## Modifications Notices

No. 2017013AE(ON)

**Modification notice of change of shape and structure design due to prevention of flux penetration of DIP switch A6E-N series.**

**[ Changes ]**

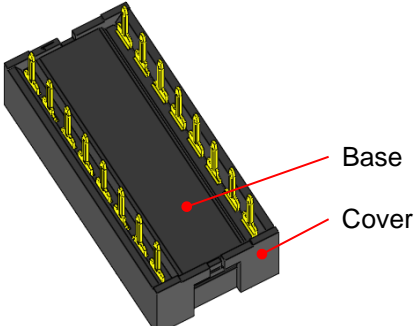
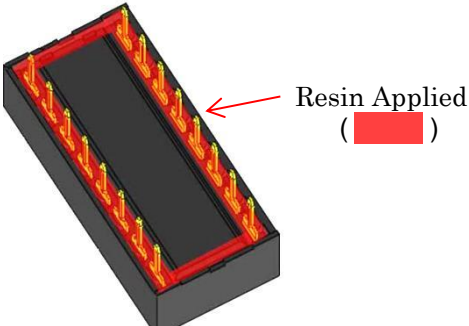
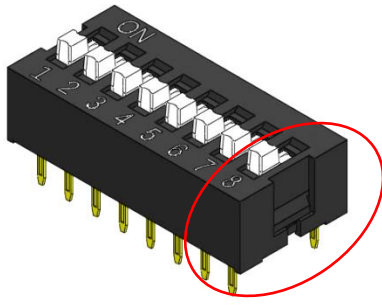
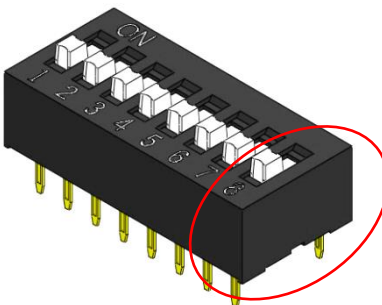
To prevent contact failures caused by flux invasion.

Before the change	After the change
<p><b>Applying the resin</b> Resin is not applied between Base and Cover.</p> 	<p><b>Applying the resin</b> Resin is applied between Base and Cover.</p> 
<p><b>Change of cover</b></p> 	<p><b>Change of cover</b> Change the cover shape due to the applying the resin.</p>  <p>There is no change of the product performance.</p>
